विषय — मथा जिलान्तर्गत गगा जल उद्यवह योजना के तहत गया एवं बोधगया शहर में पेयजल आपूर्ति के लिये पाइप लाइन बिछाने हेतु वन (संरक्षण) अधिनियम, 1980 के तहत 2.1109 हें० वन भूमि अपयोजन प्रस्ताव पर पृच्छा अनुपालन के संबंध में।

गया जिलान्तर्गत गंगा जल आपूर्ति योजना के तहत गया एवं बोधगया शहर में पेयजल आपूर्ति के लिए को किनारे पाईप लाइन बिछाने हेतु वन (संरक्षण) अधिनियम, 1980 के तहत 2.1109 हेठल वन भूमि अपयोजन प्रस्ताव पर पृच्छा प्रतिवेदन उपलब्ध कराने के संबंध में।

TRANSVERSE LAYOUT OF ROW FOR PIPE LAYING
WATER DISTRIBUTION IN GAYA AND BODH GAYA
UNDER GANGA JAL AAPURTI YOJANA

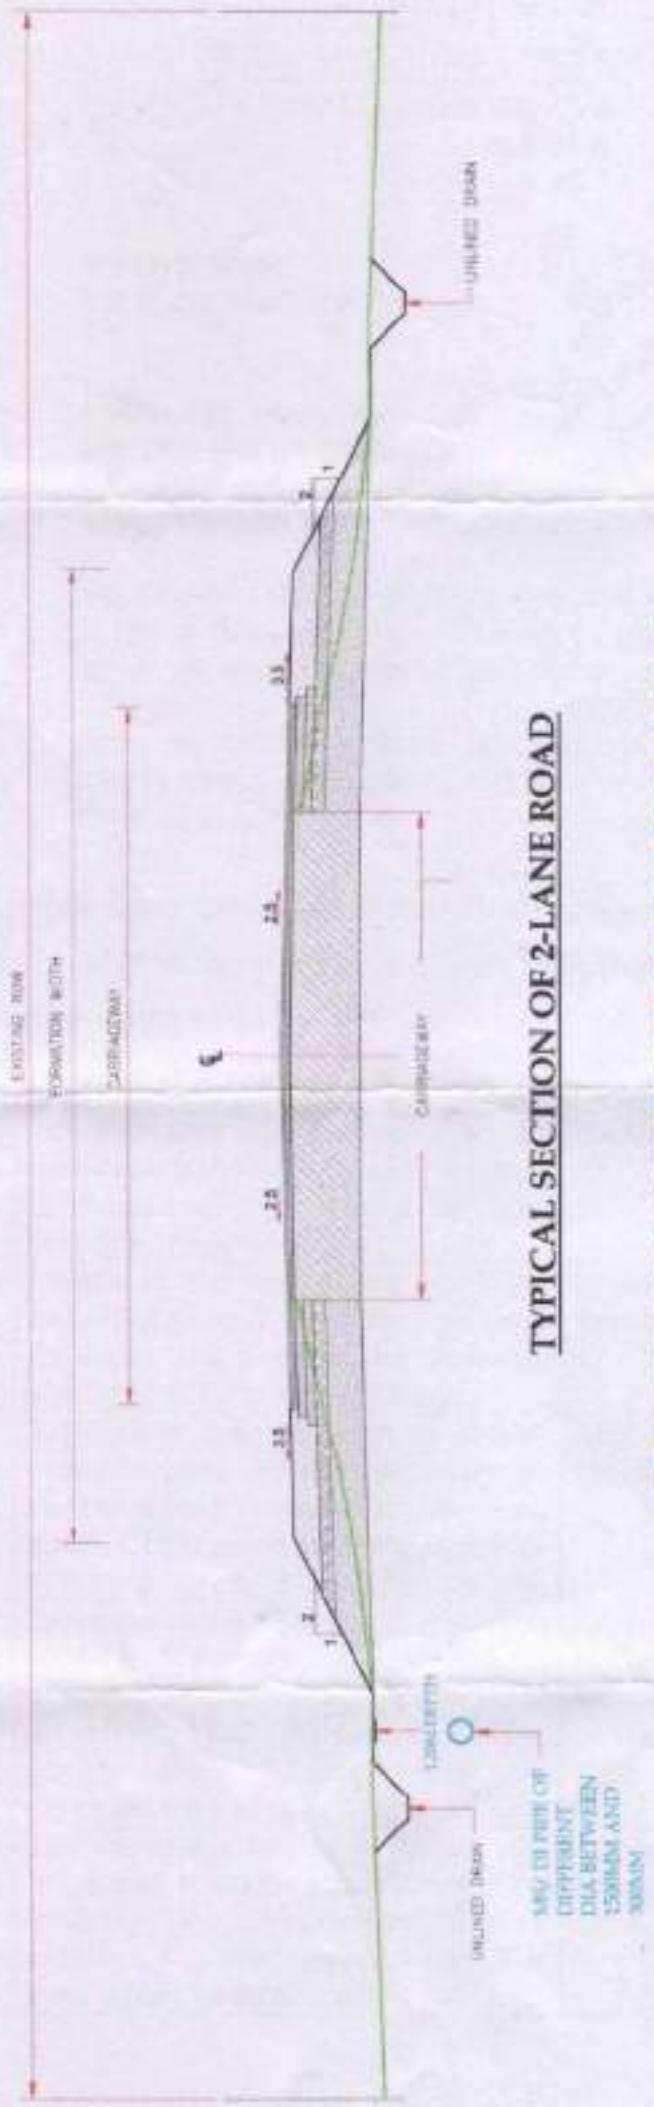
क्रम सं.	पृष्ठा	निराकरण
1	The extensive layout along with the transverse involved in the ROW under consideration should be submitted/uploaded.	कार्यपालक अभियन्ता, तिलैया नहर प्रमंडल, वजीरगंज के पत्रांक 865 दिनांक 05.07.2023 द्वारा प्रतिवेदन उपलब्ध कराया गया है जो इस पत्र के साथ सलम्न है। प्रयोक्ता एजेंसी द्वारा इसे परिवेश पोर्टल पर भी अपलोड कर दिया गया है।
2	Details of the tree enumeration list including name of the species in the forest land proposed for diversion should be filled in Part-II online	वन प्रमंडल पदाधिकारी, गया का पत्रांक 2488 दिनांक 09.06.2023 द्वारा परियोजना निर्माण में प्रभावित होने वाले दृक्षों की गणना सूची उपलब्ध कराया गया है जो इस पत्र के साथ सलम्न है। प्रतिवेदन को परिवेश पोर्टल पर भी अपलोड कर दिया गया है।
3	Toposheet map (in high resolution colored toposheet) with delineation of the forest land proposed for diversion and CA land along with the signature of the concerned DFO and user agency	प्रयोक्ता एजेंसी द्वारा अपयोजित होने वाली वन भूमि एवं क्षेत्रपूरक वनीकरण के लिये विनिहत वन भूमि को टोपोशीट मानचित्र पर अफित करते हुए परिवेश पोर्टल पर अपलोड कर दिया गया है।

S. No.	Observation raised from Railway	Compliance	Remarks
I	The extensive layout along with the transverse involved in the ROW under consideration should be submitted/uploaded.	Enclosed with this letter.	
II	Details of the tree enumeration list including name of the Species in the forest land proposed for diversion should be filled in part-II Online.	Related with Divisional Forest Office.	
III	Topo sheet map (in high resolution colored topo sheet) with delineation of the forest land proposed for diversion and CA land along with the signature of the concerned DFO and user agency.	Related with Divisional Forest Office.	
IV	Proposed forest land for diversion is 2.1109 ha but as per DSS analysis total proposed forest land is 3.381 ha (base on uploaded kml file). Correct kml file of the forest land proposed for diversion need to be uploaded.	Corrected KML file is ready for uploading at website.	
V	The vegetation density of the forest is mentioned 0.3 in the online application whereas the Vegetation density mentioned in the uploaded part II is zero. It may be rechecked.	Related with Divisional Forest Office.

No. G45T2
Scale 1:50,000

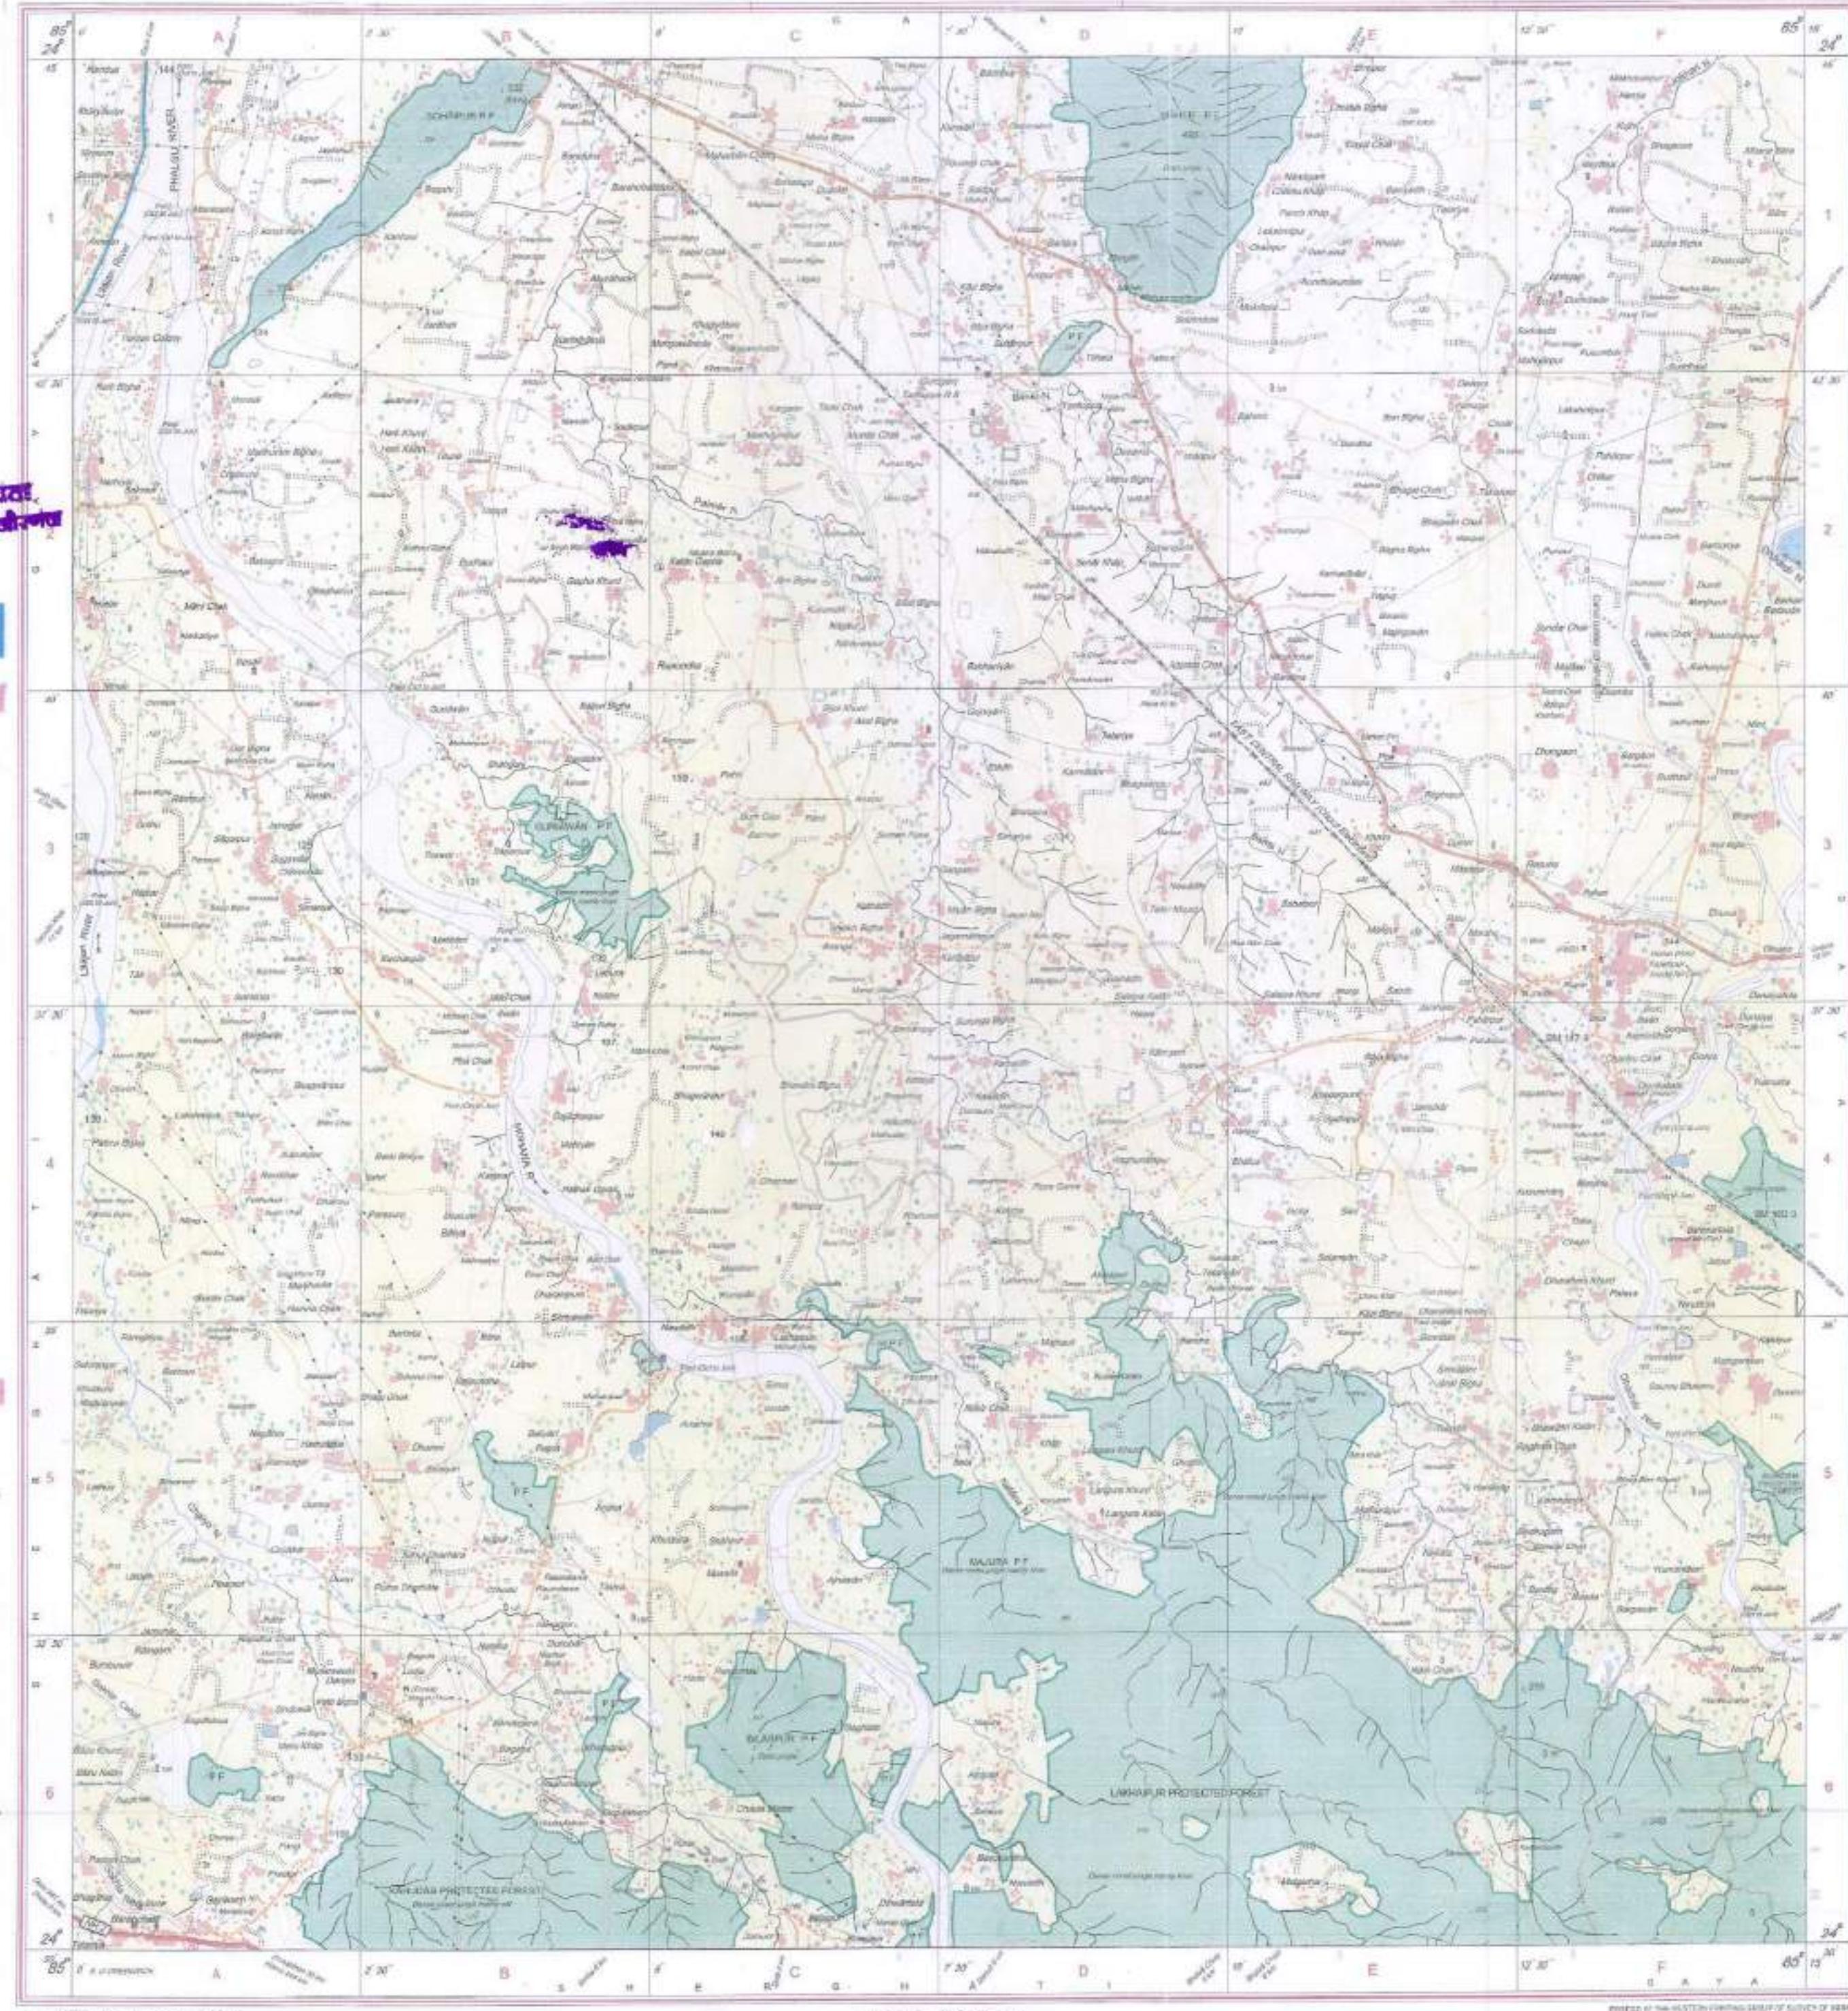
उपरोक्त विषयक संबंध में सूचित करना है कि विषयाक्ति परियोजना में प्रधान संविध द्वारा मांगी गयी कण्ठका-II दृष्टों की सूचि एवं कण्ठका-III में Toposheet में Diverted CA Land चिनित कर निविधित खाक के द्वारा भेजी जा रही है।
